NYMNP EMAIL DATED 18 MAY 2022 – ANGLO AMERICAN WOODSMITH RESPONSE – NYM/2022/0286/CVC LADYCROSS PHASE 4 CONDITIONS DISCHARGE

**HYDROGEOLOGICAL RISK ASSESSMENT - PHASE 4 - NYMNPA CONDITION 88
& 90 - LADYCROSS**

40-ST5-LC-2100-EN-RA-00002

11.4. ATTACHMENT D – POTENTIAL RECEPTORS

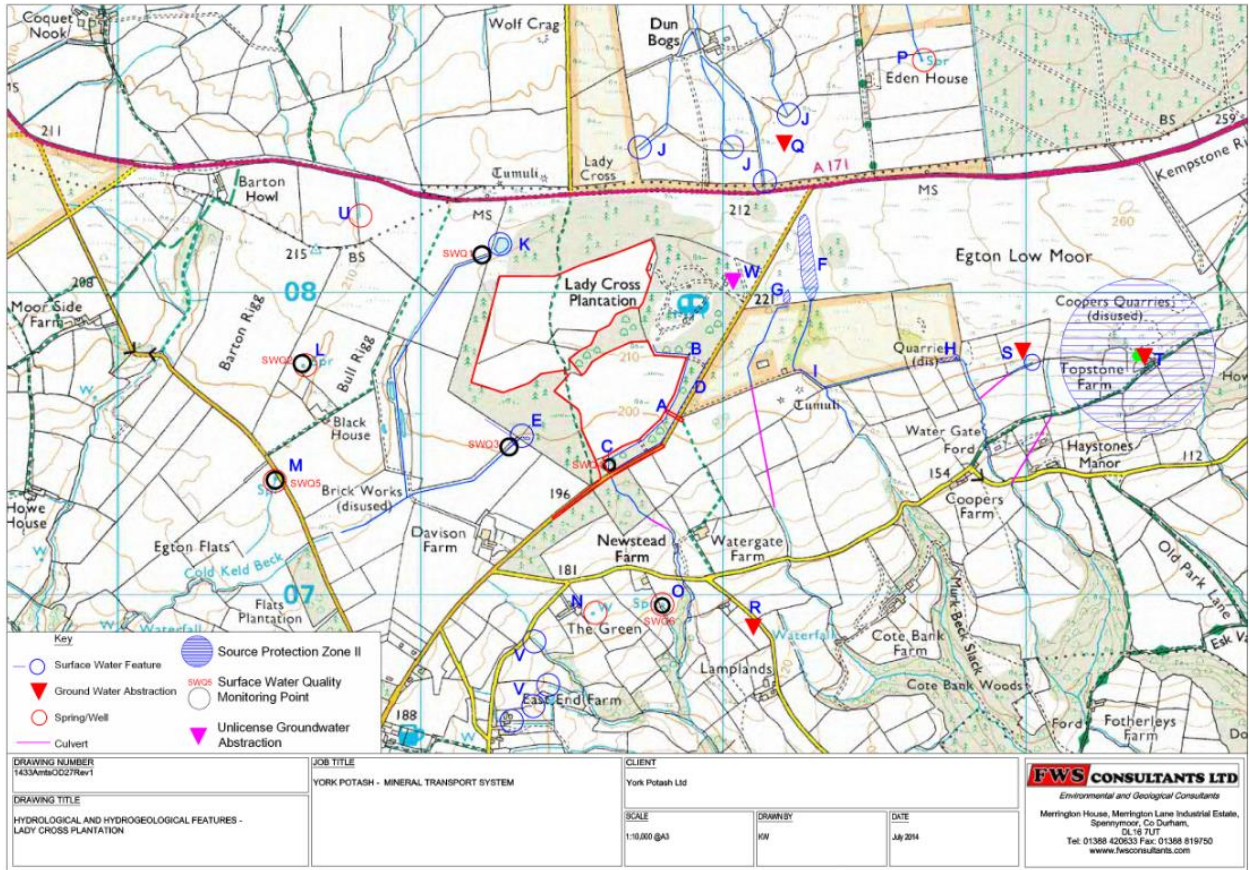
Table 6.2 of the Hydrogeological Risk Assessment identifies a number of receptors and their sensitivity. It is noted that a 'Low Sensitivity' rating is attributed to surface water courses that are tributaries of the River Esk. The related Table E1 defines Low Sensitivity as 'tolerant to change and of low or local importance'. This rating is queried taking into account the known sensitivity of the River Esk in ecological terms and it would be useful if either further justification for this rating were provided, or the assessment revised accordingly.

A revised version of the document is included with this response, in which the sensitivity has been amended to the correct rating of 'Moderate-High' rather than Low. As source magnitude (Table 6-1) for all the effects considered ranges from Negligible to Minor, the risk rating for watercourses would be unchanged and remain at Low. The Risk Statement (Table 6-4) remains valid as drafted.
